Access Compliance Report

Public Rights-of-Way

(Curb Ramps)

Intersection ID: 2973	Main Street: GREEN_HEDGE_AV	Cross Street: WHITE_ASPEN_PL	Location: W
ADA ID: D2BA434ED30F	Ramp Type: BlendTrans1	Initial Pass/Fail: Fail	Overall Compliance: No
Severity Score: 18.75			
Codes/Mitigation Info/Possible Solution		Field Measurements/Component Compliance

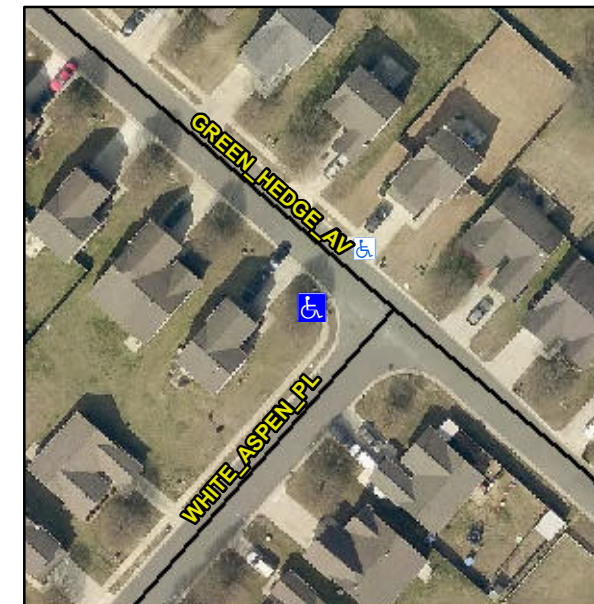
R304.5.1, R304.5.3

Compliance	Description	Data	Compliance	Description	Data
N/A	Ramp Length (in)	47.0	Yes	BlendTrans Slope (%)	3.9
No	Ramp Width (in)	33.0	No	BlendTrans XSlope (%)	3.8
N/A	Flare Type LT	N/A	N/A	Flare Type RT	N/A
N/A	Flare Slope LT (%)	N/A	N/A	Flare Slope RT (%)	N/A
N/A	Flare Traversable LT?	N/A	N/A	Flare Traversable RT?	N/A
N/A	Landing Length (in)	N/A	N/A	DWS Provided?	N/A
N/A	Landing Width (in)	N/A	N/A	DWS Contrast?	N/A
N/A	Landing Slope (%)	N/A	N/A	DWS Length (in)	N/A
N/A	Landing X Slope (%)	N/A	N/A	DWS Full Width?	N/A
N/A	Landing Curb? (Y/N)	N/A	N/A	DWS Offset (in)	N/A
N/A	Shared Landing?	N/A			
N/A	Gutter Ponding?	N/A	N/A	Gutter Slope (%)	N/A
N/A	Gutter Lip Ht (in)	N/A	N/A	Gutter X Slope (%)	N/A
N/A	Painted X Walk1?	No	N/A	Painted X Walk2?	N/A
	X Walk 1 Direction	To NE		X Walk 2 Direction	N/A
	X Walk 1 Width (in)	N/A		X Walk 2 Width (in)	N/A
	X Walk 1 Slope (%)	2.2		X Walk 2 Slope (%)	N/A
	X Walk 1 X Slope (%)	1.7		X Walk 2 X Slope (%)	N/A

Remove & Replace Curb Ramp With Two New Directional Ramps or Equivalent.
